Newcombe House

Minor Material Amendments Update Presentation

May 2025

1). Reduction to the façade depth to NCH tower

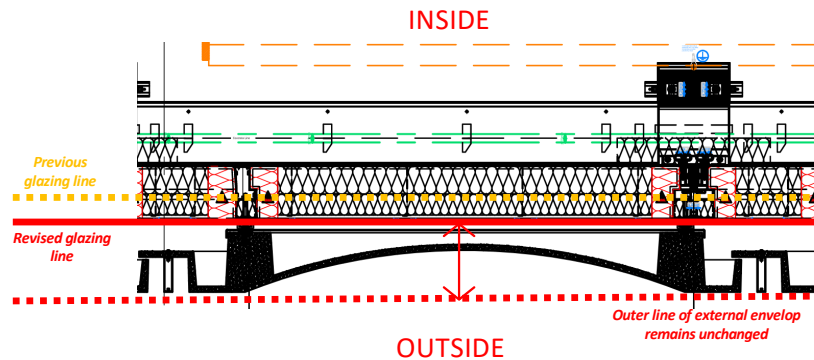
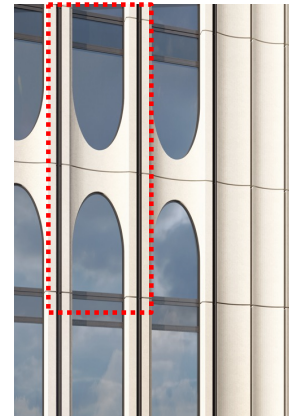
- Façade depth to the tower has been reduced to lighten the loading on the retained structure.
- Proportion and geometry, including scalloped profiling, are still maintained from the consented scheme – see imagery opposite.
- Expressed joints and datums remain unchanged.
- Reduction to façade depth has no impact on solar shading / energy performance to the office building.

3). Revised door locations to Office Entrance:

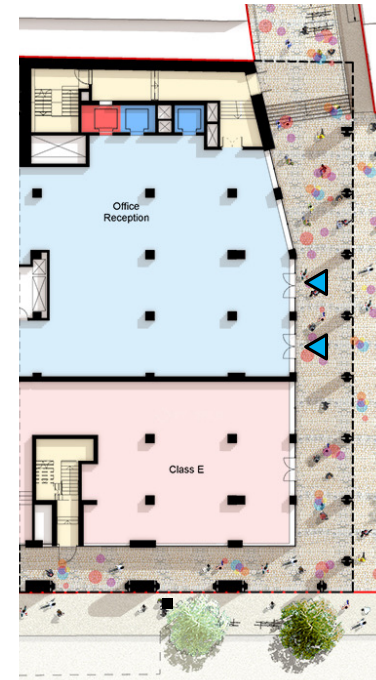
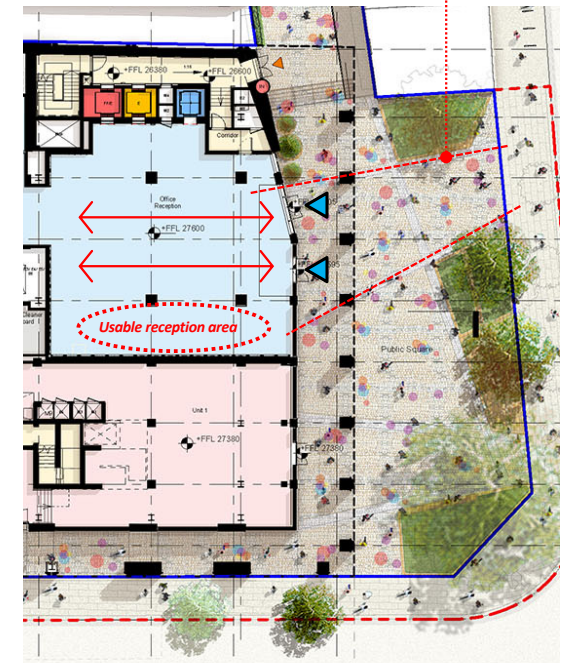
- Updated to suit optimised interior reception layouts.
- Refer to visual overleaf for proposed reception layout.

Door re-arrangement
Is centred on the opening
formed within the wider
landscaping proposal

4). Colonnade update to east elevation

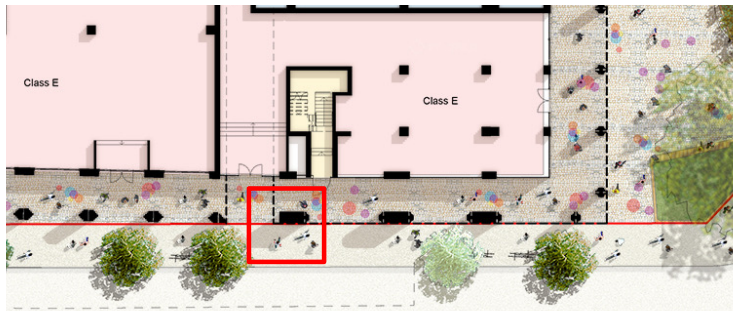
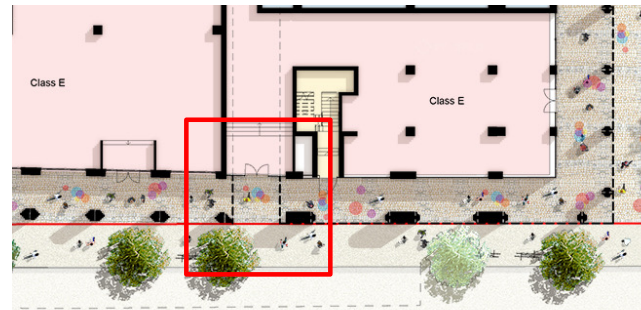
- Developed structural strategy to improve colonnade symmetry and accessibility at grade.

5). Update to link elevation between KCS and NCH buildings:

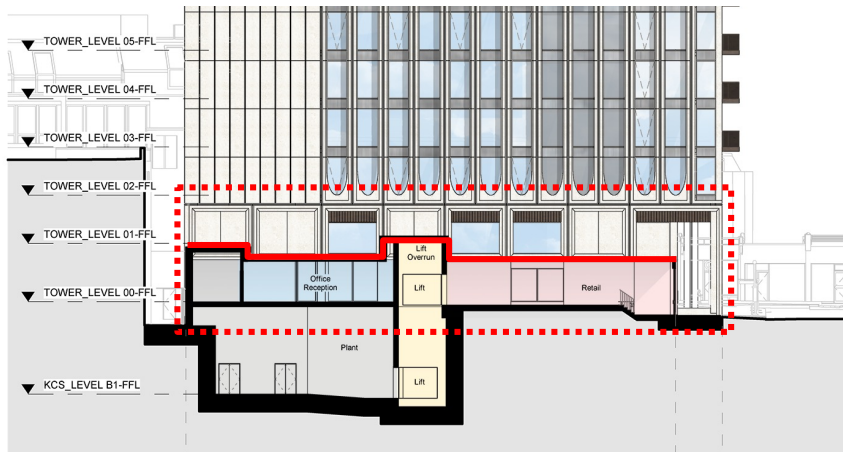
- Updated to suit access into NCH retail unit and fire escape from NCH tower.
- Improved elevation at ground level that maximises activation of frontages.

6). Revised elevation to KCS and NT with improved roovescape to Link Building

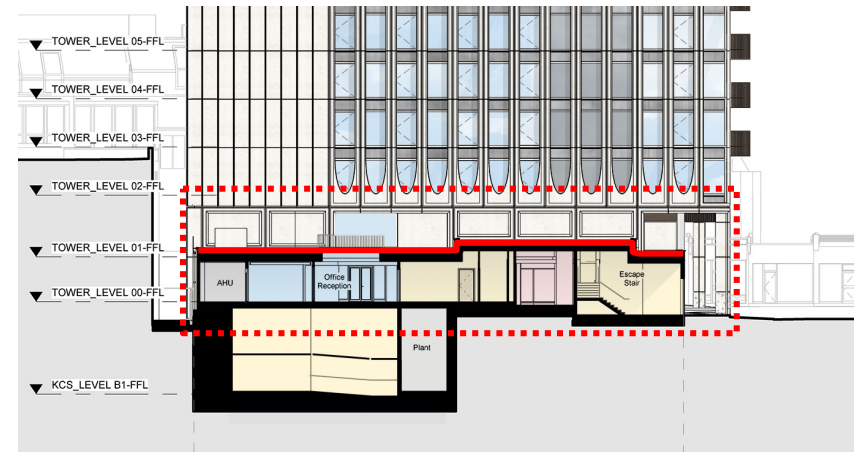
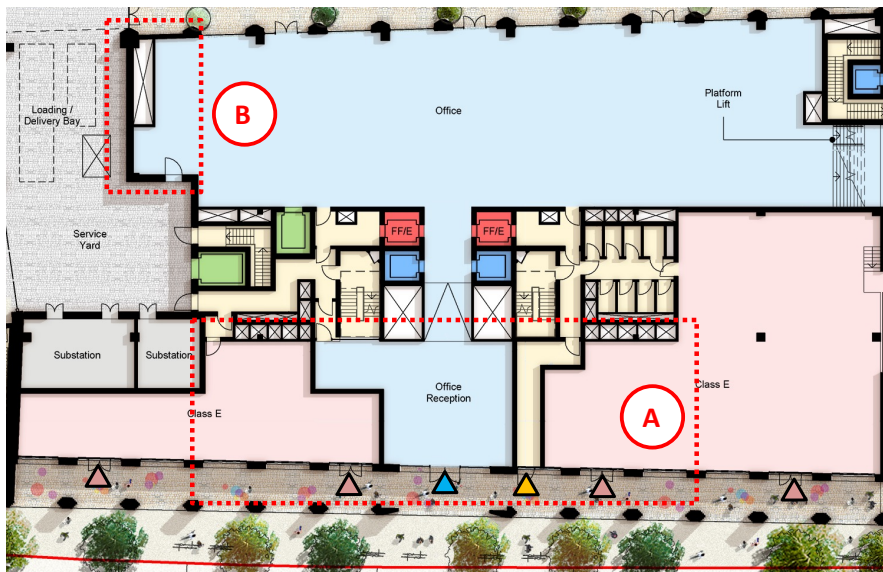
- Simplification of roof design with internal layout arrangement.
- Extent of glazing to roof developed with interior design intent.
- This affords the scheme to improve the roof profile to the Link Building and rationalise the façade design to Newcombe House Tower.

1). Amendments to GF Retail and Office layouts

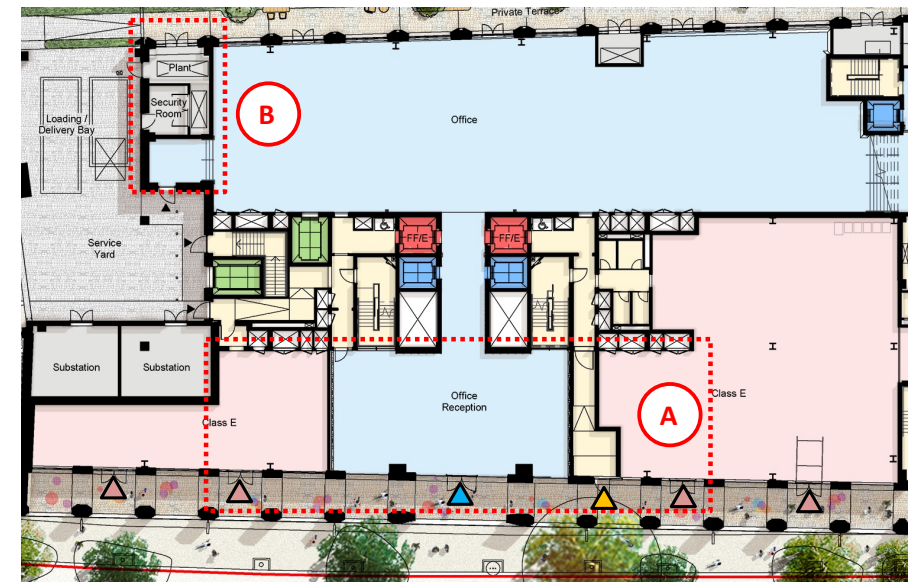
A. Increased KCS Office Reception to establish a reception space proportionate to office provision of the KCS building.

- Amendments improve visibility, wayfinding and activation along KCS colonnade frontage.
- Door locations for fire-egress and retail access have been amended.

B. Security room added to Loading / Delivery bay to monitor deliveries.

2). Principal façade updates

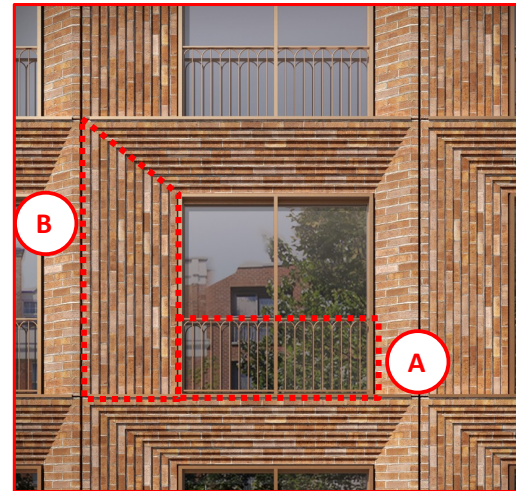
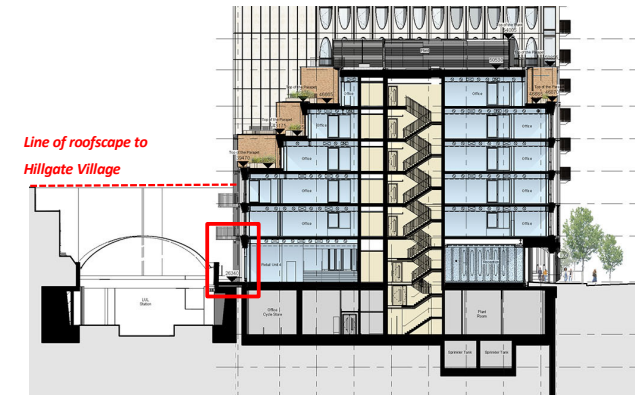
- A. Handrails reduced to openable window sections.
 - 'Lightens' architectural treatment of façade language across KCS frontage.
- B. Brickwork detailing amended with brick orientation changed to improve interfacing detailing.
- C. External doors at 5th floor terrace level amended to a double doorset.

3). Updates to rear elevation:

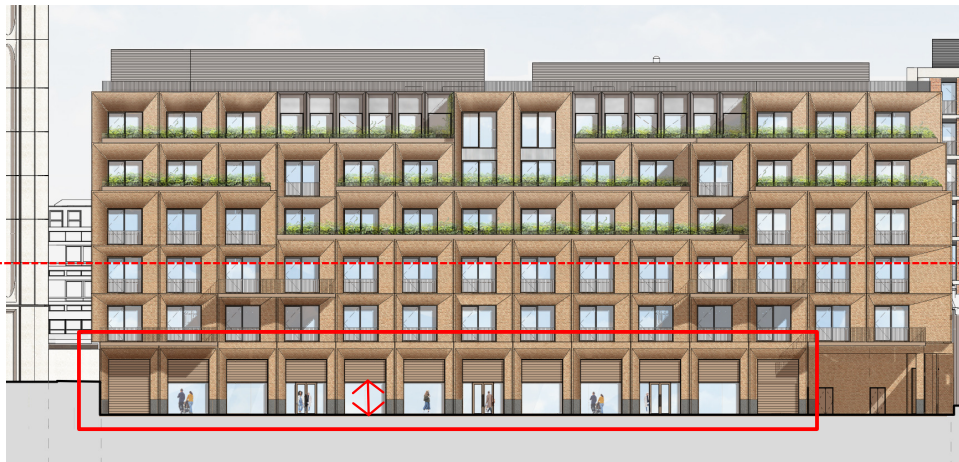
- Similar handrail updates from previous slide.
- Improved glazing to louvre ratio to increase daylight onto internal floor area.
- Update to louvred sections to façade for air intake / extract to basement plant/
- Proposed changes are not visible from local townscape incl. Hillgate Village.

4). Introduction of external RWPs to rear elevation

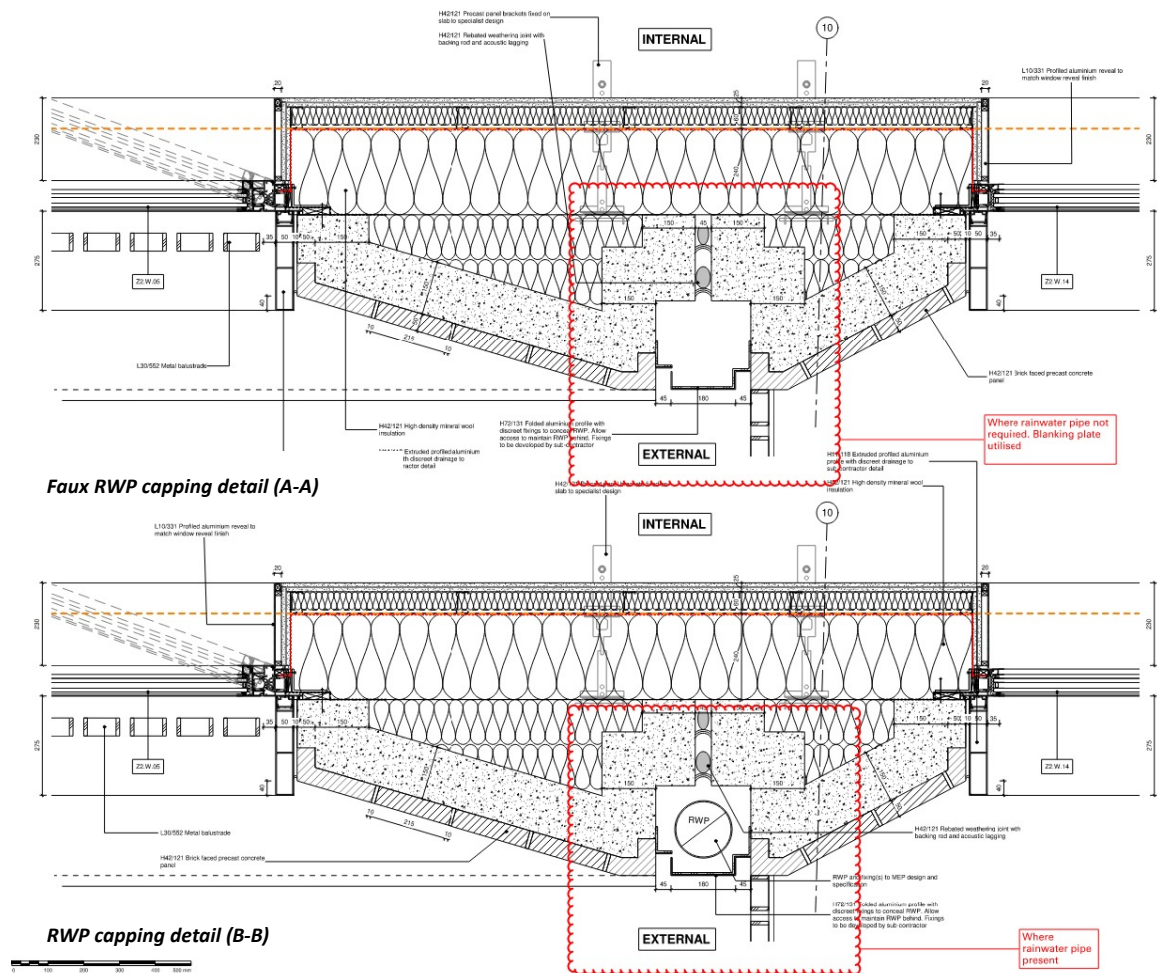
- External RWPs introduced to the rear elevation of the KCS building to remove the risk of water ingress from rainwater drainage from the series of cascading terraces.
- The location and design of the RWPs, which are clad in pressed aluminium cappings, accentuate the modular design of the façades to the KCS building.
- Where RWPs are not located, addition vertical cappings have been introduced to ensure consistency within the façade's modular rhythm.
- The amended design enhances the architecture's modular expression to the rear elevation, whilst complimenting the townscape view from Hillgate Village.

5). Development of PVs and ramp gantry at roof level:

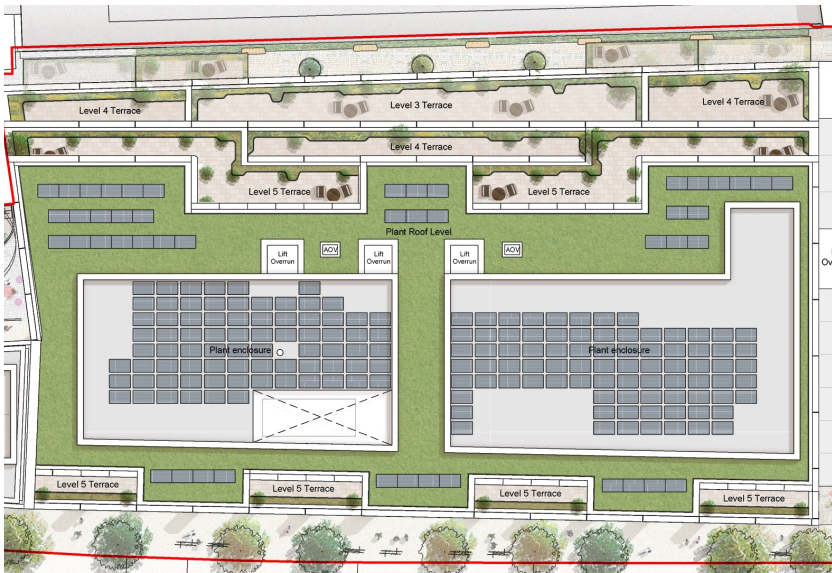
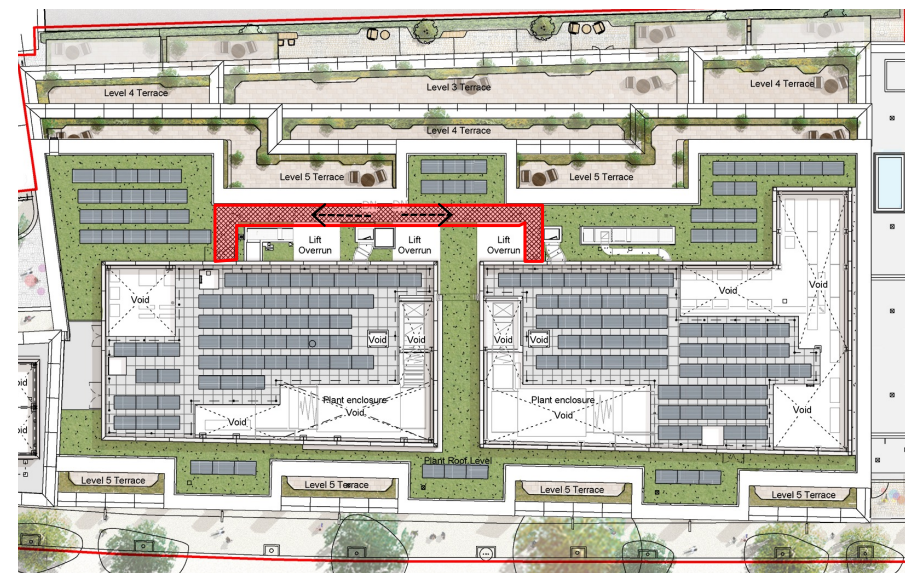
A. Due to restraints on massing, roof access cannot be achieved via lift.

- Introduction of a gantry and ramps (indicated in red below) are therefore required to assist with level and safe access for the movement of replacement parts.

B. PV arrangement has been revised to accommodate MEP plant enclosure to suit free-area arrangements.

- No change to on-site energy provision / Part-L requirements.

6). Reduction in KCS Service Yard clear height:

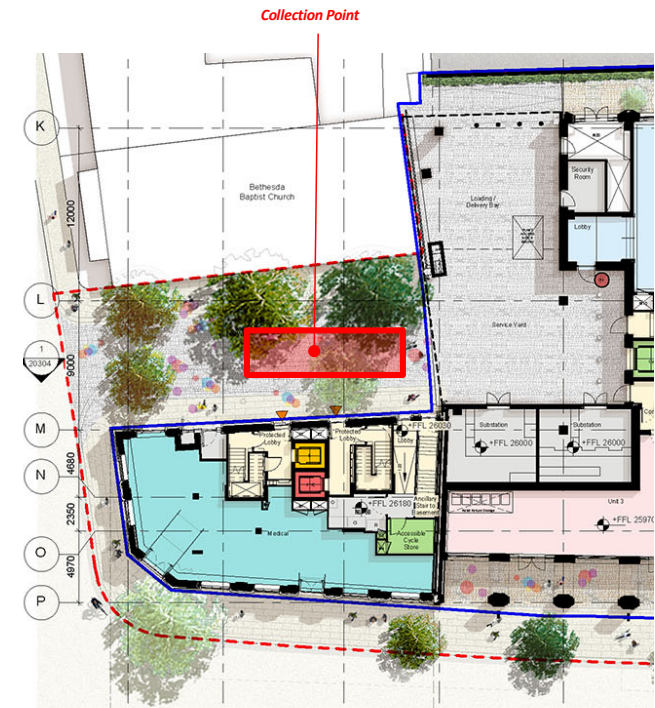
- Development of high-level MEP services required within the service yard.
- Subsequently reduces the clear height from 4.5m to 4m clearance and concealed the required services within the ceiling.

1). Change of use at basement level

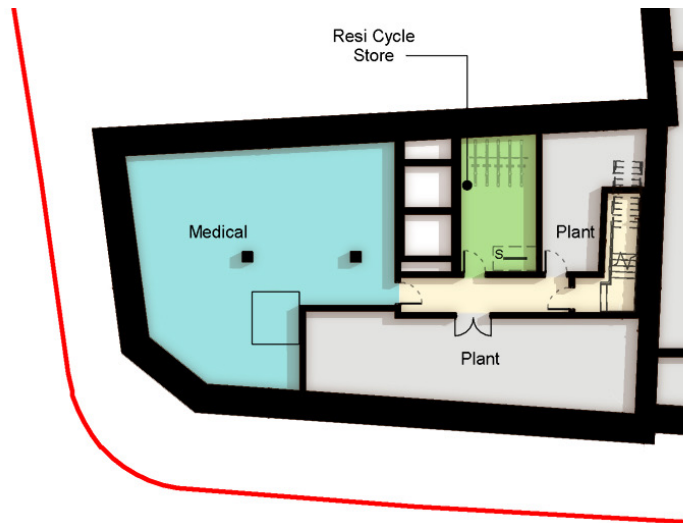
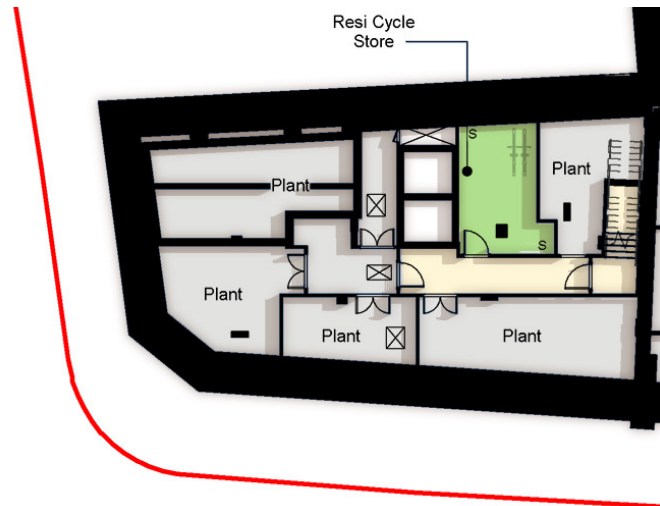
- Medical use has been omitted from basement level to accommodate life safety plant under new Building Safety Act.
- Revised medical GIA is complies with local policy in the provision of a minimum 650 sqm.

2). South façade updates:

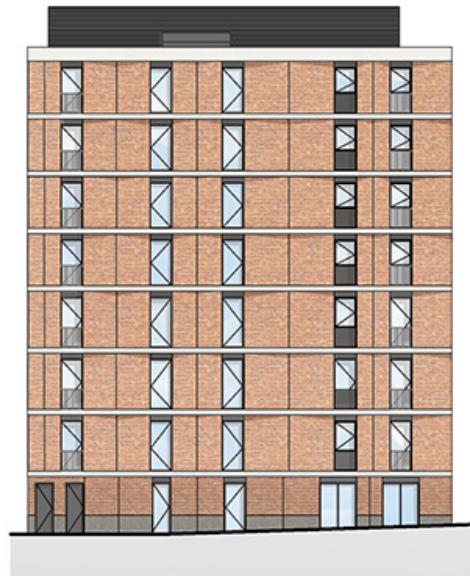
- A. Omission of glazing to bathroom owing to inward opening windows for cleaning / maintenance.
- B. Increase to grillage above windows for mechanical ventilation requirements.
- C. Precast banding increased to accommodate blue roof provision.

2). Rear façade updates:

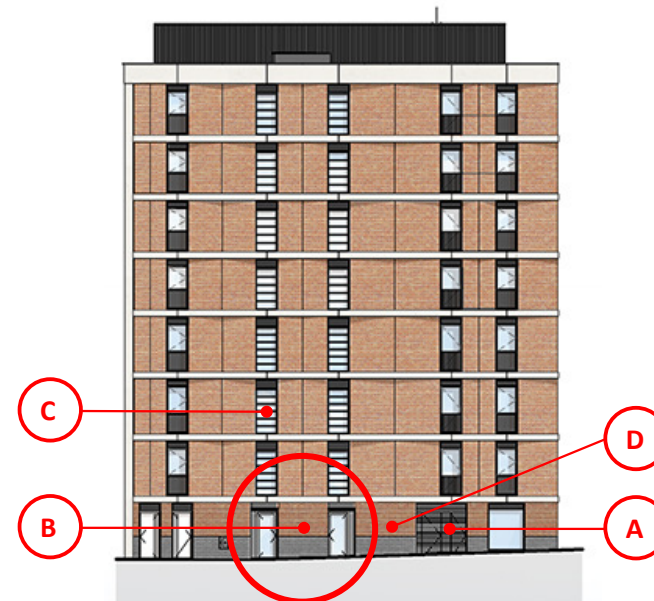
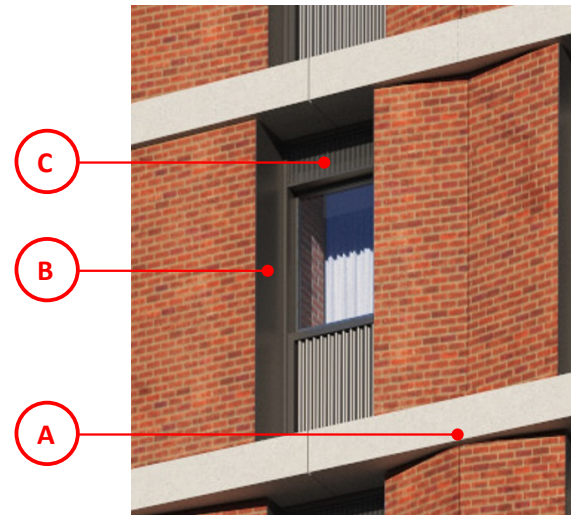
- A. Louvres introduced at ground level for necessary plant rooms for life-safety equipment.
- B. Canopies introduced to residential entrances with increased clear widths for improved accessibility.
- C. Glazing updated to fire-lobbies to accommodate AOV for smoke clearance to comply with regulatory requirements.
- D. Omission of faceted panelling at ground to improve security, as per SBD principles.
